S U B M I S S I O N: Rogley
a written submission by way of objection to DA 2020/0442

Re:
231 Whale Beach Road Whale Beach NSW 2107
DA 2020/0442

WRITTEN SUBMISSION: LETTER OF OBJECTION
Submission: Rogley

Demolition of the existing Apartment and Retail Building and Construction of a New Shop Top Housing Development

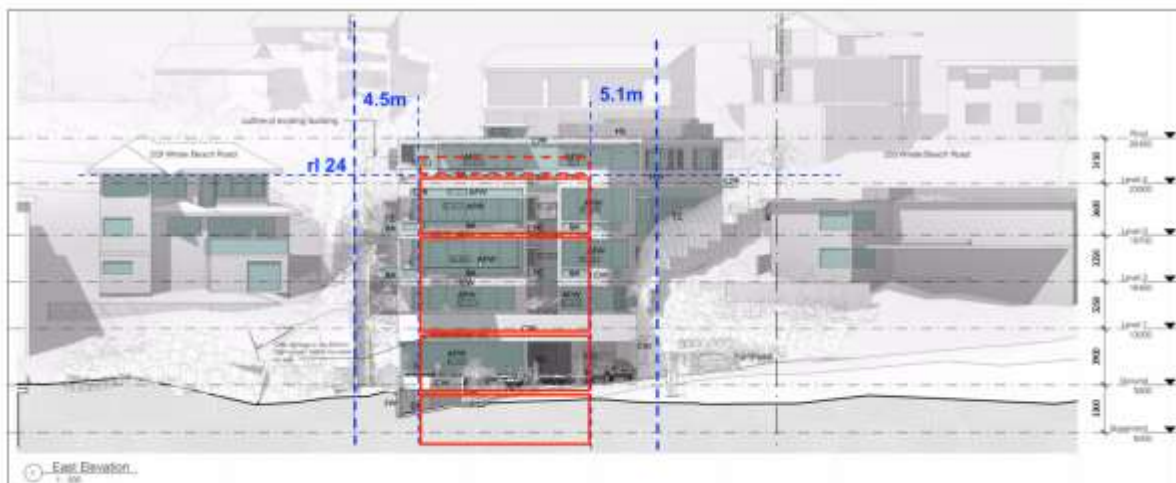
Allowing for 2 x Commercial @ 3.6m [7.2m] + 3 x Residential @ 3.0m [9.0m] + 1 Carpark @ 2.7m, the overall building height would require 18.9m building height above the basement slab. To achieve a RL 24.0 wall height to match neighbouring sites, the Basement would need to be lowered to RL 5.1m.

The amended sectional profile would present wall heights that align with the wall heights at #229 Whale Beach Road at RL 24.0.

Plant Screens above the roof should be conditioned at a maximum of 1.2m, giving a maximum height of RL 25.2, being more appropriate massing to the roof forms within #229 Whale Beach Road.

The screens should have side setback from the roof edge by 3m. No part of the building or roof plant should be above RL 25.2.

An amended scheme could deliver:

- Basement RL 5.1m Carparking, provide additional double stackers to increase carparking
- Ground RL 7.8m Commercial & Carparking
- First RL 11.4m Residential
- Second RL 14.4 Residential
- Third RL 17.4 Residential
- Fourth RL 20.4 Commercial [Back of pavement WBR @ RL 20.75 and 21.5 balustrade not to extend past 13m contour]
- Roof RL 24.0 Roof [not to extend past 15.5m contour, preferably a greater setback to reduce the bulk]
- Plant RL 25.2 Plant, maximum permissible of any plant or lift over run, positioned at western side facing Whale Beach Road to avoid view loss.

Figure 3F.3 New development adjacent to existing buildings should provide adequate separation distances to the boundary in accordance with the design criteria

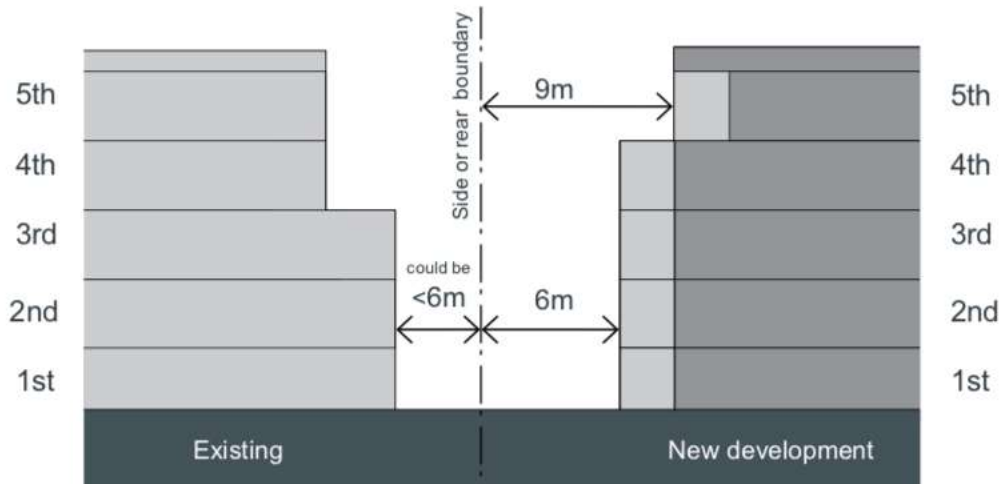
ADG: 6m side & rear setback requirement v Proposed 1.8m

Boundary conditions

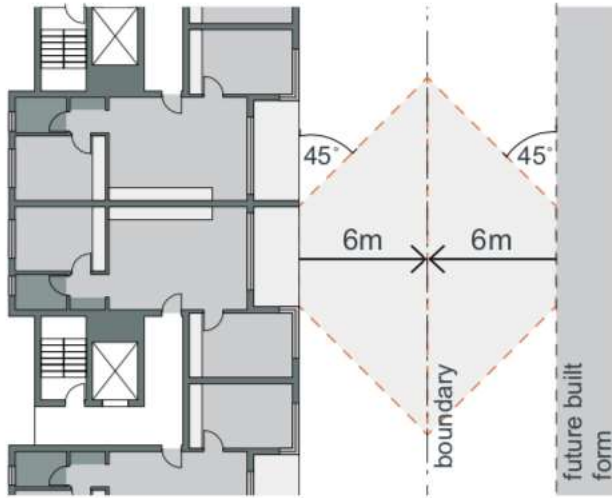
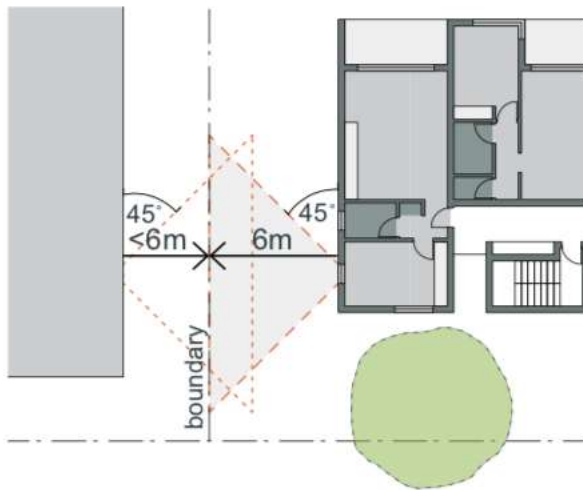
ADG: Control 6m boundary condition setback v Proposed 1.8m
